HISTORIC AND DESIGN REVIEW COMMISSION

June 04, 2025

HDRC CASE NO: 2025-090
ADDRESS: 910 E SOUTHCROSS BLVD
LEGAL DESCRIPTION: NCB 7665 LOT SW 200 OF 4 & NE IRR 118.4 OF SW IRR 233. 4 OF C & W IRR 93 OF 15
ZONING: I-1, H
CITY COUNCIL DIST.: 3
DISTRICT: Mission Historic District
APPLICANT: Edward Hernandez/Nirvana Architecture Studio
OWNER: Isarael Ramirez/LIDS CHRISTIAN CENTER INC
TYPE OF WORK: New Construction of 10,000 sf church
APPLICATION RECEIVED: April 9, 2025
60-DAY REVIEW: June 8, 2025
CASE MANAGER: Caitlin Brown-Clancy

The applicant is requesting a Certificate of Appropriateness for approval to construct a new 10,000 sf building housing an auditorium, classrooms, and various auxiliary spaces on the existing campus of LIDS Christian Center at 910 E Southcross Blvd and site work consisting of a master parking and landscaping plan.

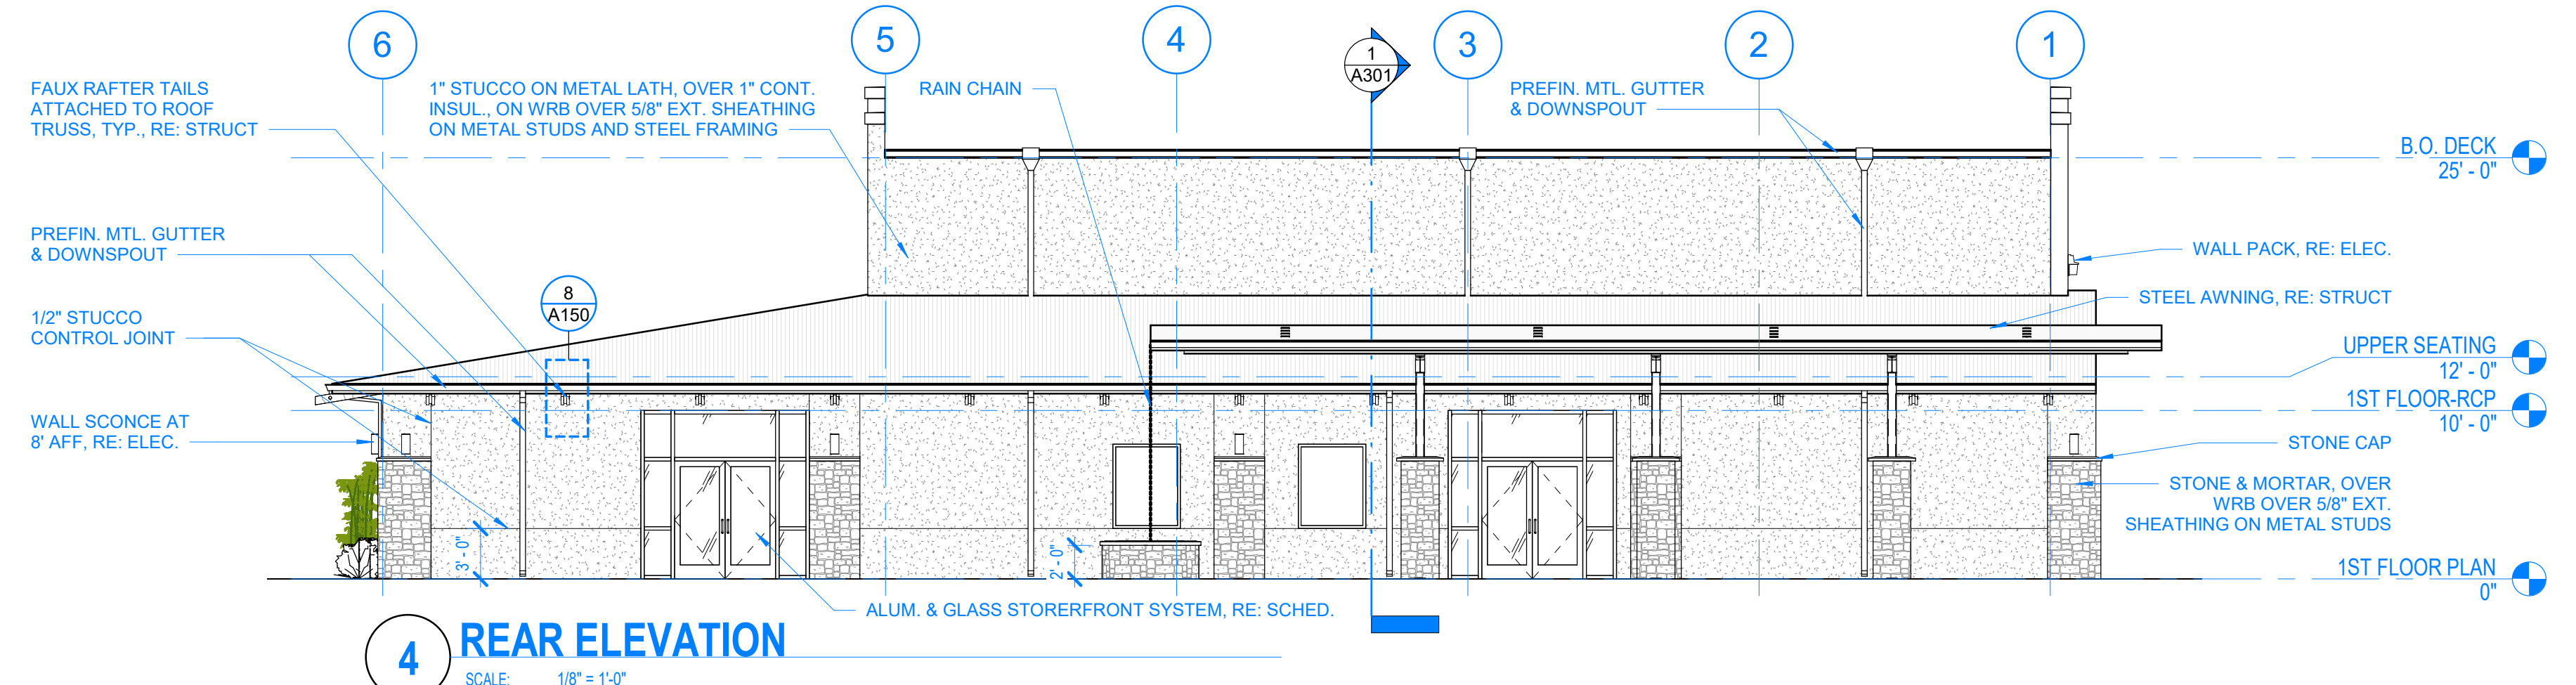
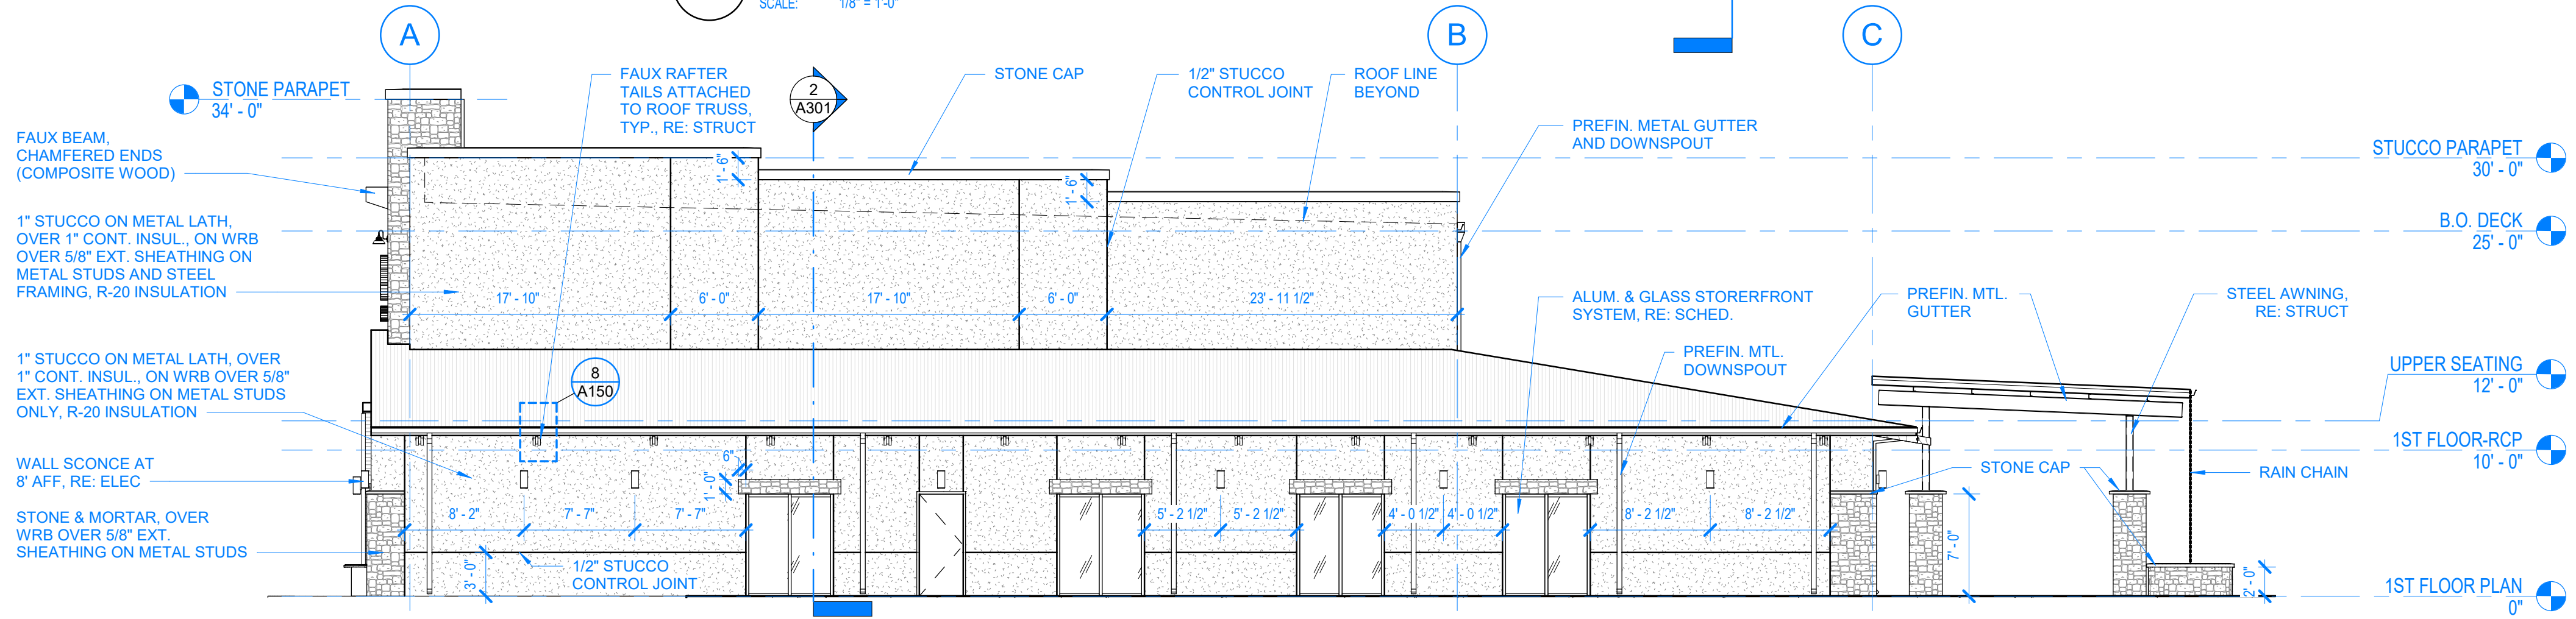
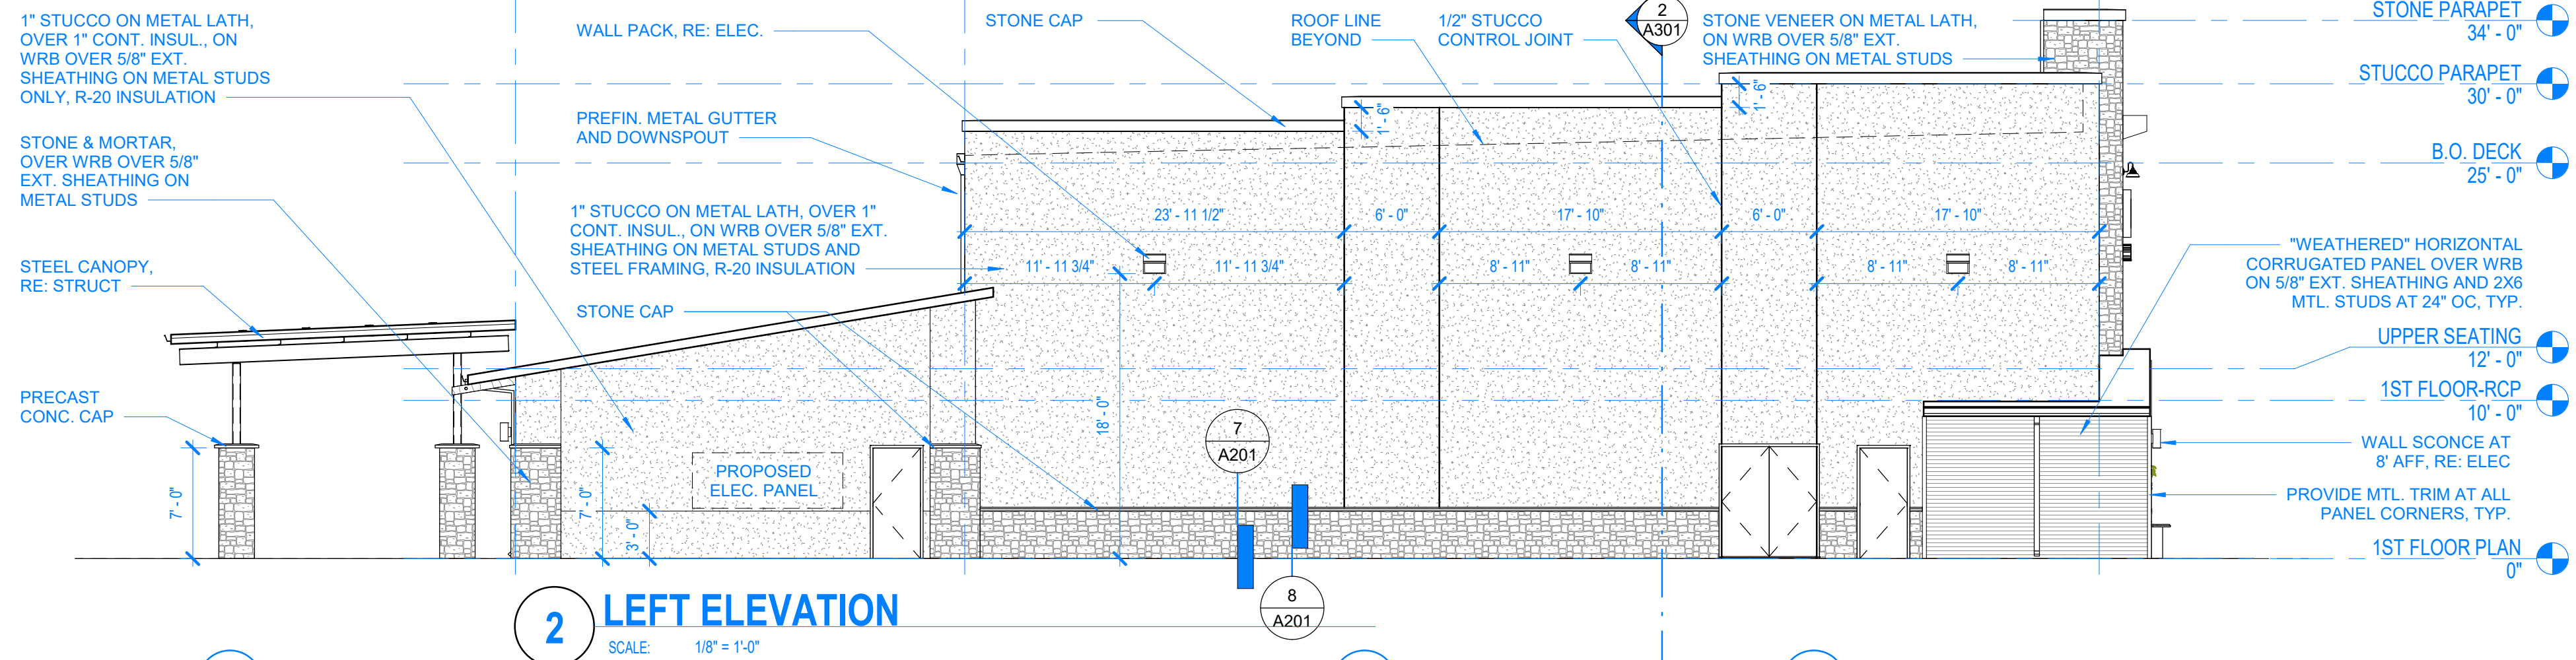
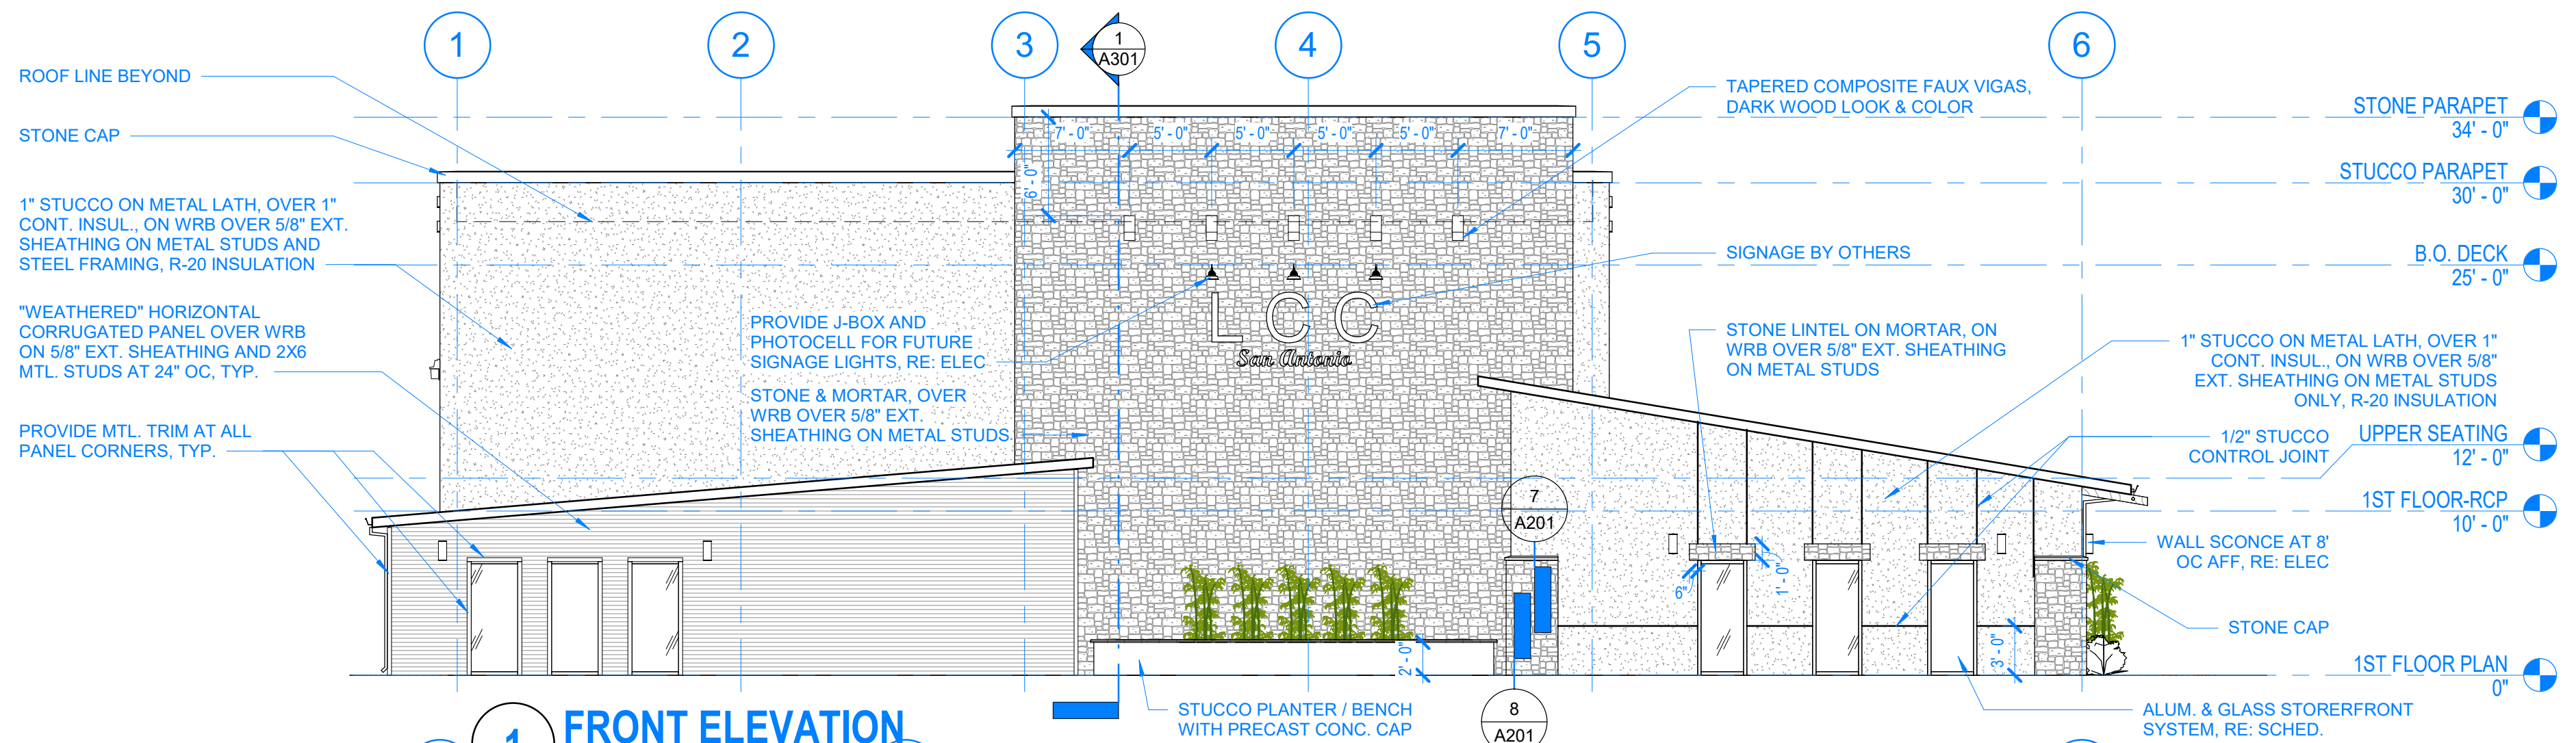
- i. **MASS, SCALE, FORM** – The applicant is requesting to construct a building whose primary façade features a hierarchical, massive, central form flanked by a secondary form to the West and a tertiary form to the East. The design calls for a transition in height of 32'0" at the highest roof projection of the ROW façade to 18'0" at the rear façade. The applicant utilizes transitions, material changes, and surface reliefs/control joints to provide interest to an otherwise monolithic expanse. Guideline 3.B.i states that Wall planes and fenestration patterns should be organized to yield facades that appear monolithic and enduring while still allowing for visual interest through breaks in scale and pattern. Staff finds the proposed form and mass consistent with the Guidelines particularly given the language of the adjacent structures to the property.

- m. **WINDOWS** – At this time, the applicant has not submitted exact window specifications. The drawing indicate use of a typical storefront fenestration system on the primary, rear and Western facades. Staff finds the applicant should install windows that meet the Standard Specifications for Windows in New Construction and that the applicant should submit product specifications for review prior to returning the HDRC for final approval.
